Pentium® II Processor Specification Update

Release Date: June 1999

Order Number: 243337-027

Figure 1. UP Dual Ended Termination (DET)

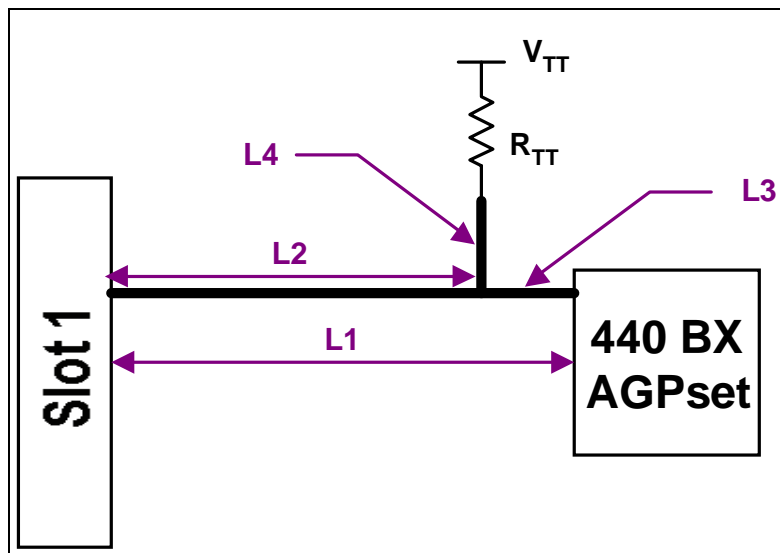
IMPLICATION: This violation of the bus exchange protocol when using a reduced arbitration latency may cause a system-level setup timing violation on the address, address parity, request command, or request parity signals on the system bus. This may result in a system hang or assertion of the AERR# signal, causing an attempted corrective action or shutdown of the system, as the system hardware and software dictate. The possibility of failure due to the contention caused by this erratum may be increased due to the processor's internal active pull-up of these signals on the clock after the signals are no longer being driven by the processor.

For UP-DET topologies (see Figure 1), the trace length L1 must be between 1.5" to 4.5" while using a 56Ω termination resistor.
